PRODUCT SUPPORT

BULLETIN NO. 218

MACHINE: **All Hydra Spikers B, Super B and Super B-2's; Hydra Hammers; and M3's - with Nippers**

SUBJECT: Tie Hook Cylinders

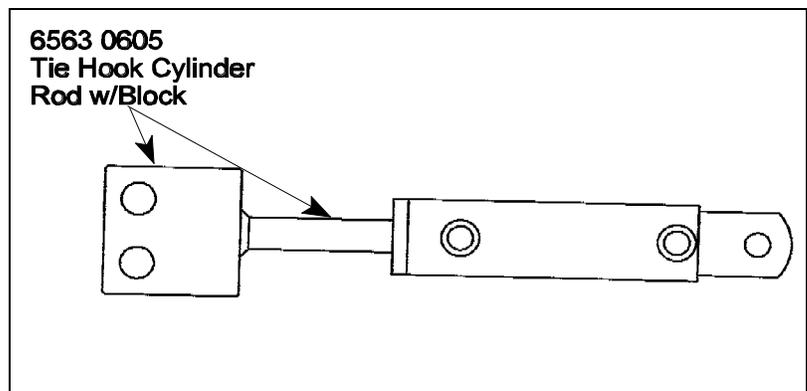
There have been some complaints from the field that the 2855 1797 Tie Hook Cylinder rod fails where it threads into the 1822 6500 Rod Guide.

A new 2855 1800 Tie Hook Cylinder, which has the rod guide welded to the cylinder rod, is now available. The 2855 1800 Tie Hook Cylinder is made up of the 2855 1797 Tie Hook Cylinder with the 1822 6500 Rod Guide welded to the cylinder rod.

The 2855 1797 Tie Hook Cylinder can be upgraded by replacing the cylinder rod with a 6563 0605 Tie Hook Cylinder Rod w/ Block, see illustration.
